# CITY PLANNING COMMISSION

- APPLICATION:
- A. Ratify Negative Declaration
  - B. Special Permit to construct a 101,400 square foot office building and a 95,600 square foot parking structure (Sec. 3-B-10)
  - C. Variance to locate required parking off site (Sec. 6-D-14)
  - D. Lot Line Merger

LOCATION: South side of 'K' Street, between 17th and 18th Streets

APPLC. NO. P84-208

TYPICAL PARKING LEVEL

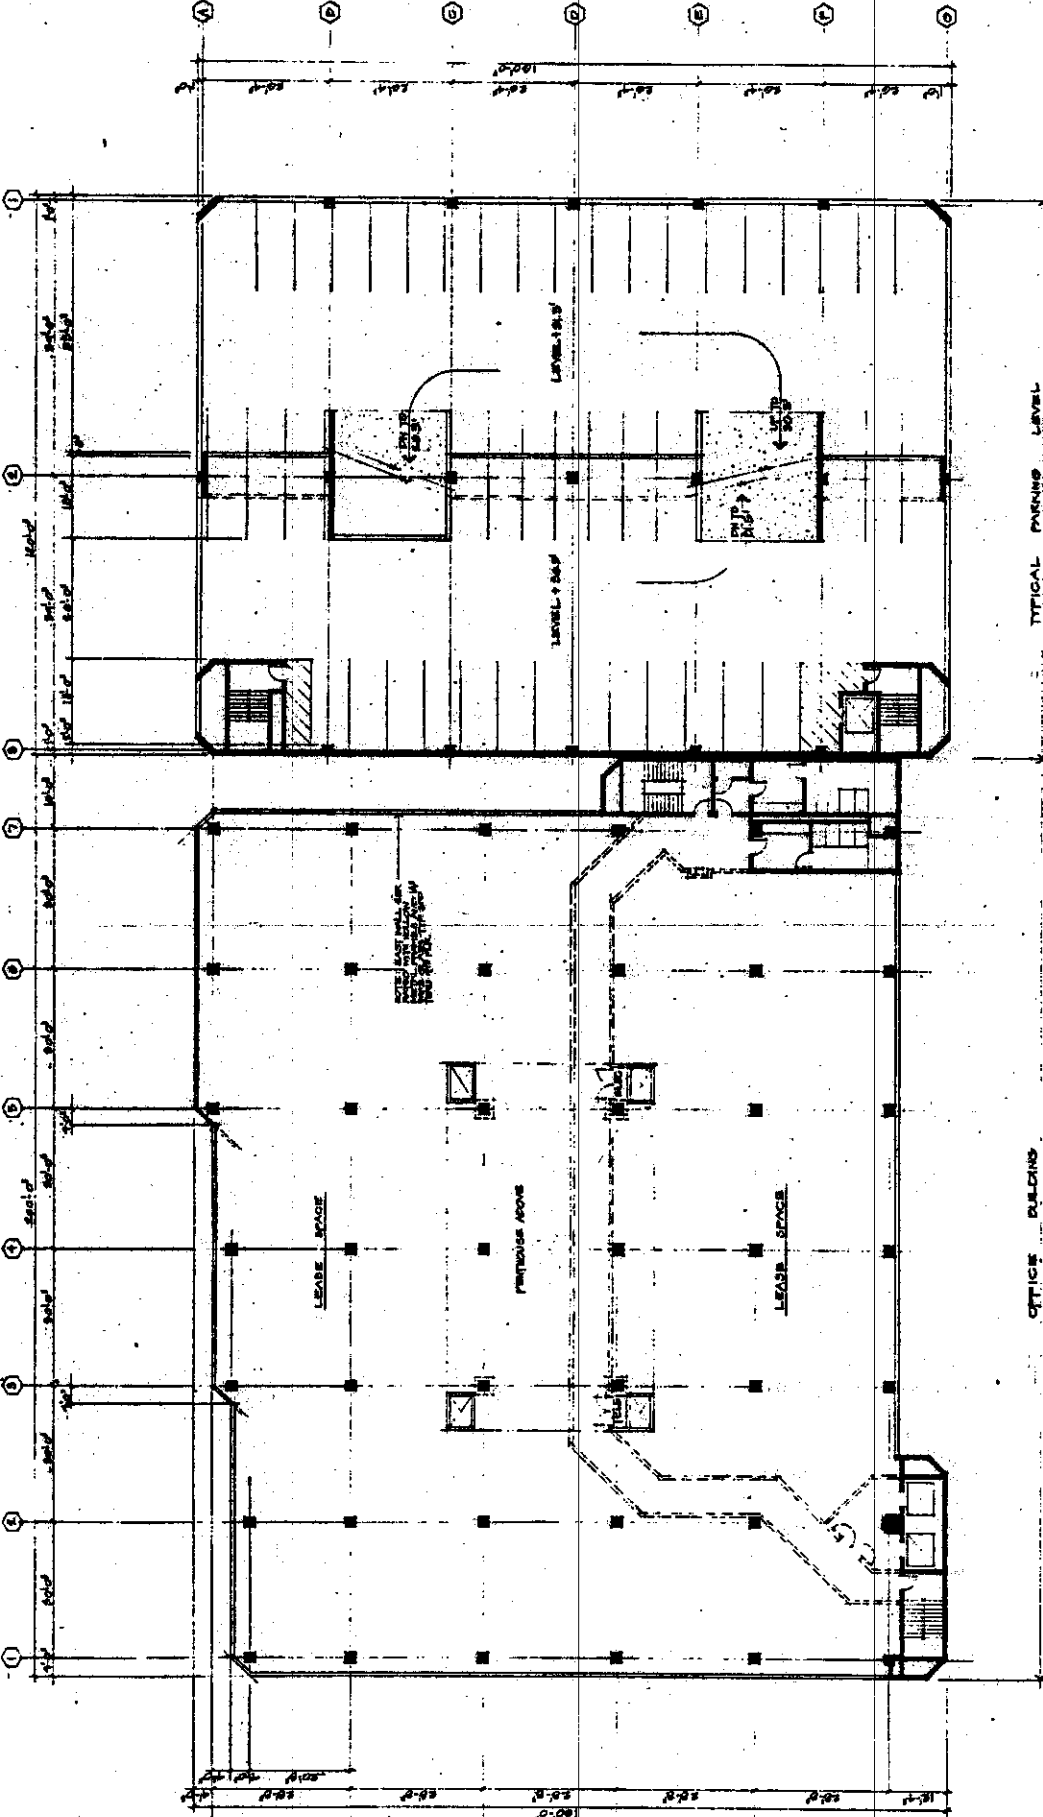
6. The City Traffic Engineer expressed concerns with the design of the parking structure. An additional 12 feet must be added to the interior ramps to create a "blend" area to prevent cars from high-centering or tail-dragging. This will require a major and costly redesign of the structure, probably entailing additional height. In addition, the Traffic Engineer notes there is no access to the office elevators from the alley for delivery purposes.
